MIL-F-52749C(ME)
AMENDMENT 1
26 July 1994

MILITARY SPECIFICATION

FORWARD AREA REFUELING EQUIPMENT

(FARE)

FIGURE 2. Nozzle-to-vehicle ground cable assembly.

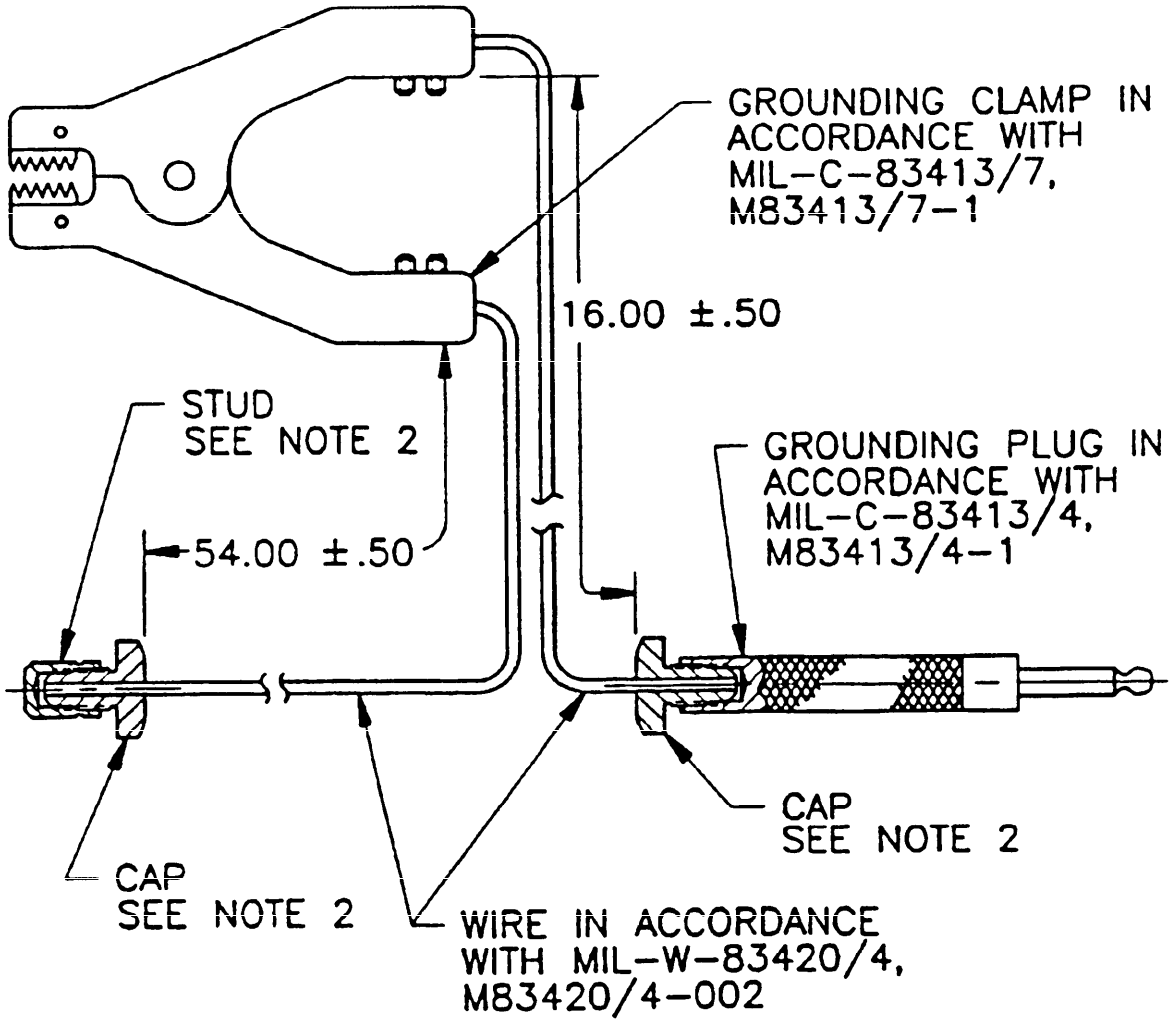
3.8.1.1, delete second sentence and substitute: "The nozzle to vehicle ground cable shall conform to figure 2.".

FIGURE 2, delete entire figure and substitute new figure.
